**SOIL/SITE EVALUATION
 for ON-SITE WASTEWATER SYSTEM**

SURVEY FOR

LOT 1, AS SHOWN IN MAP # 2003 - 729

Show profile locations and other site features (dimensions, reference or benchmark, and North).

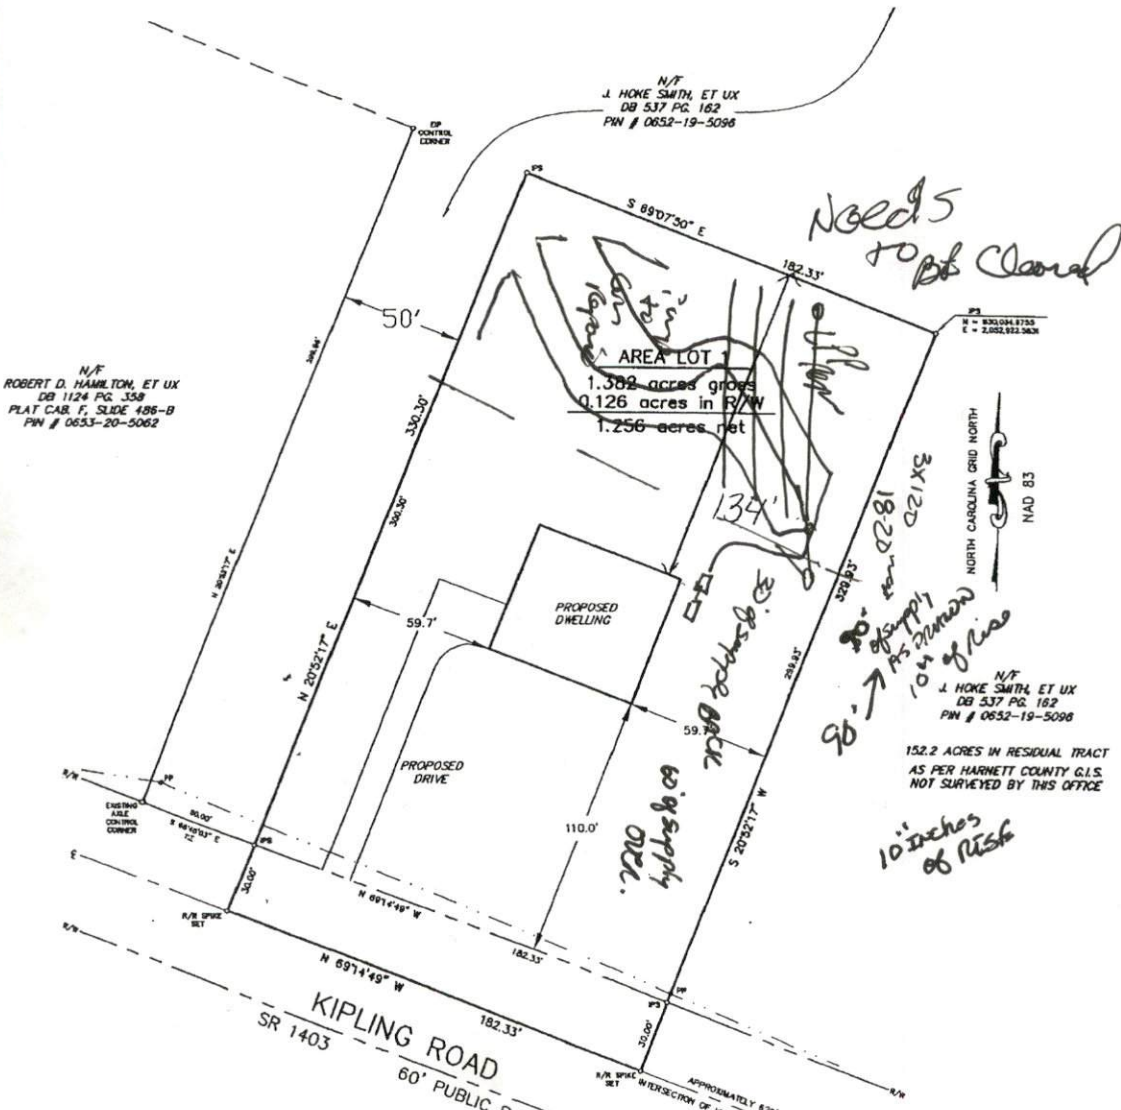
Needs to be cleared

*3x120
 18-20' max
 10' in
 of rise*

60' supply over.

10 inches of rise

*Continuation
 to meet
 on 8876 prior to installation
 at 3 kgd 18-20' max
 250' radius
 545'*
